TALLAWONG STATION **PRECINCT SOUTH**

ADDENDUM URBAN DESIGN REPORT

Rev. E_10.12.2020

DEEP SOIL ON STRUCTURE TO PUBLIC DOMAIN

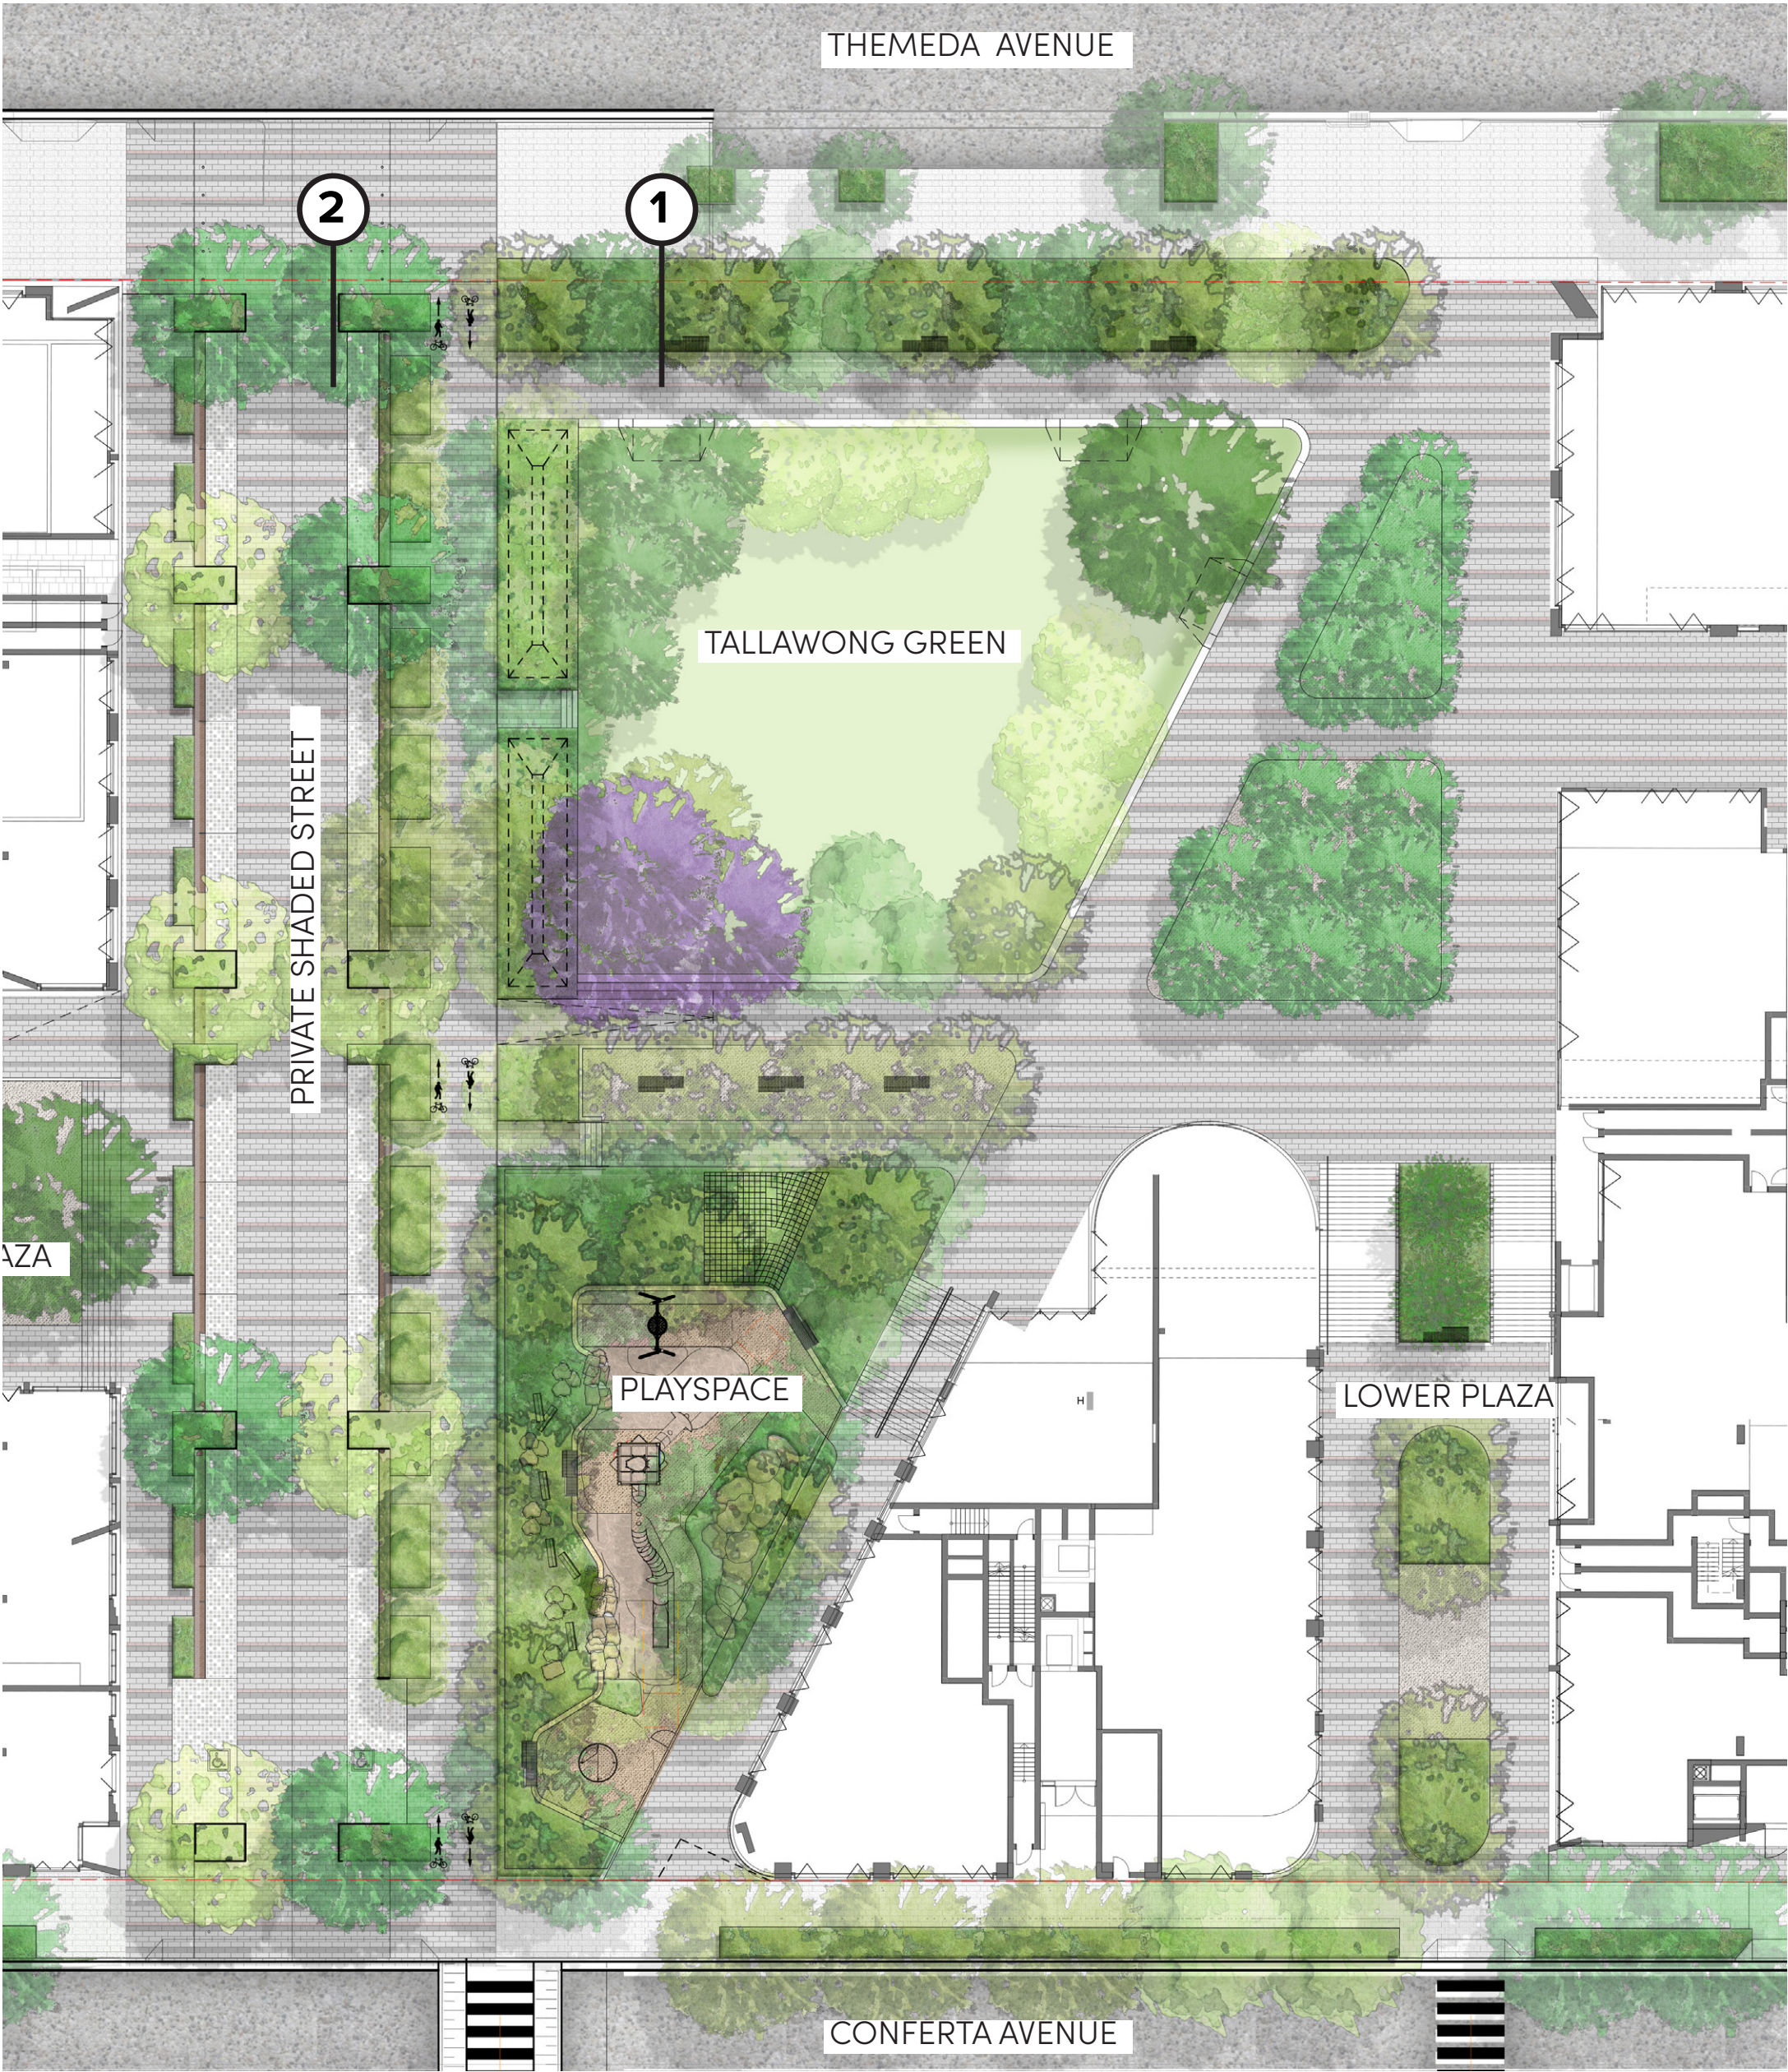
Notwithstanding the benefits of locating basement levels under the park previously detailed, there shall be no reduction in the quality, amenity or function of the park and public domain.

A soil structure analysis has been prepared by SESL Australia in support of the detailed development application to ensure there is sufficient soil depth and volume, as well as drainage and irrigation, to achieve a landscaped outcome which is not compromised.

This report concluded that an optimal depth of soil for plant and tree growth is 1.5 metres overall depth from the top of structure to the finished ground level.

Accordingly, the basement levels are to be located to achieve a soil 'vault' for the park with a minimum depth of 1.5 metres.

STREET NETWORK AND HIERARCHY

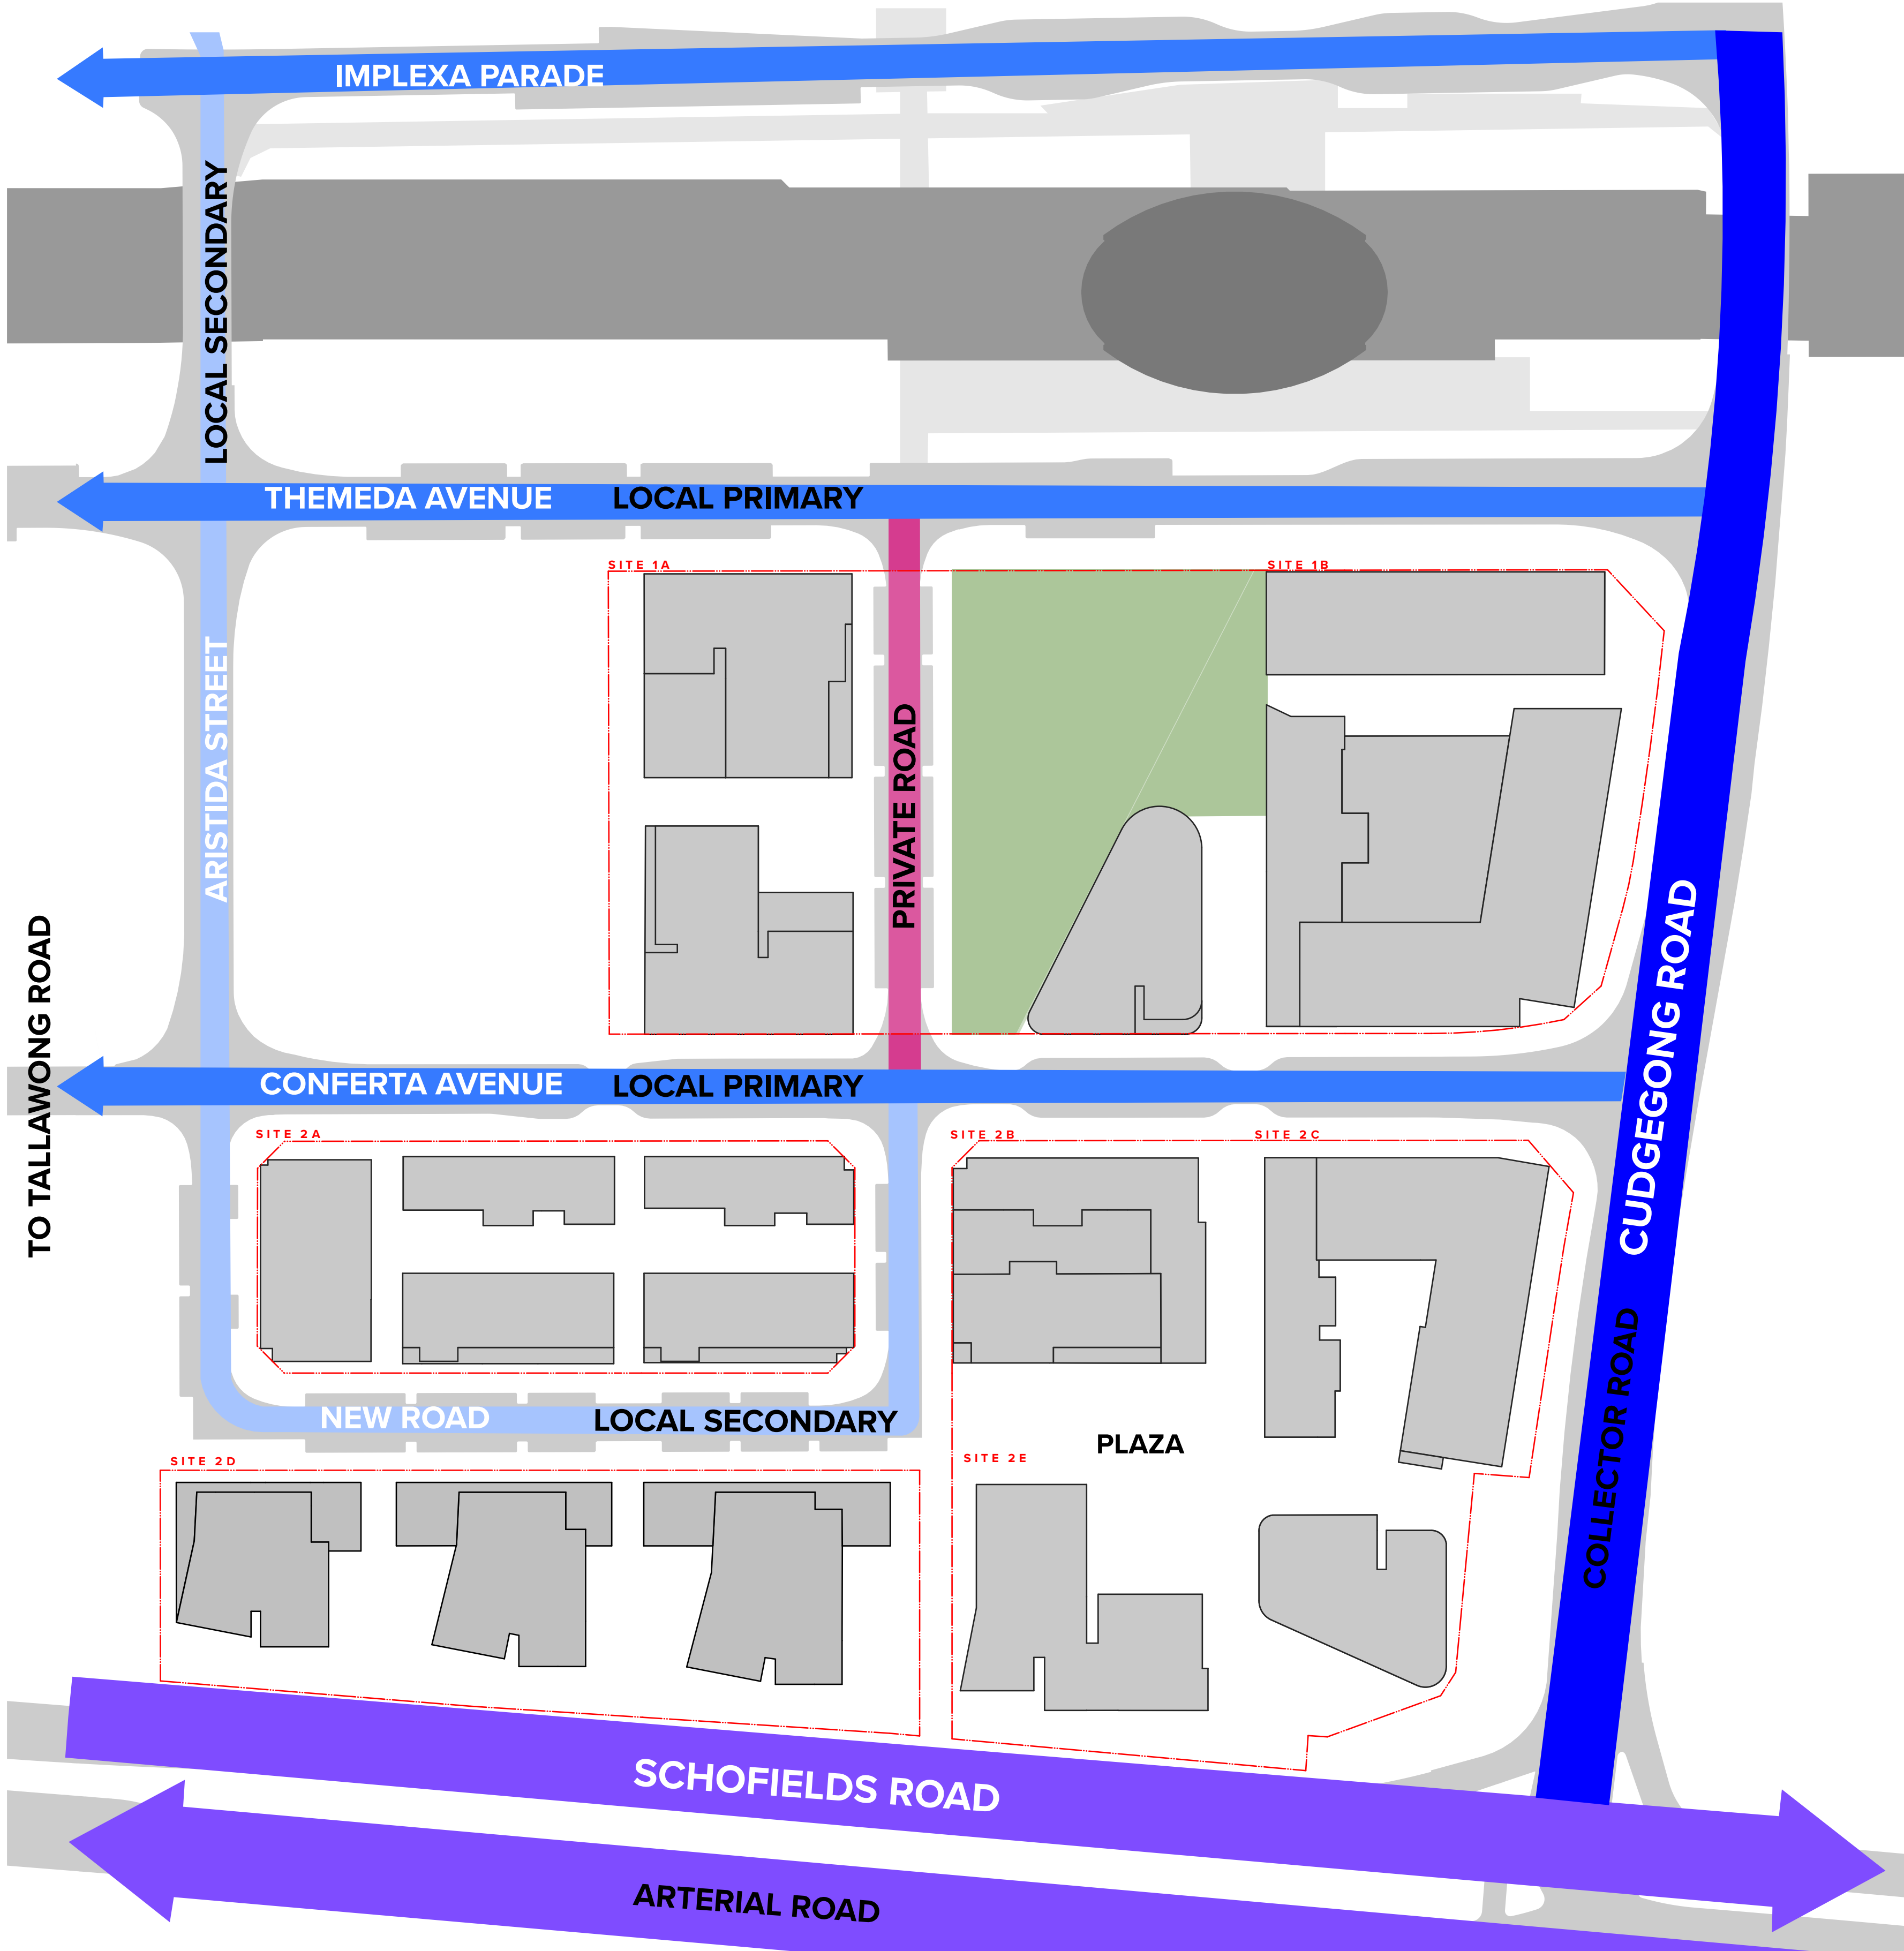
The Approved SSDA Scheme identifies a new north-south road in Site 1 to the west of the park, which connects Themeda Avenue with Conferta Avenue, which was intended to be constructed and dedicated to Blacktown City Council.

However, after discussions with Council, it is proposed that this road will be retained in private ownership with public access of the road secured on title.

This affords the opportunity to redesign the road to better integrate with the park and public domain, while reinforcing a pedestrian priority.
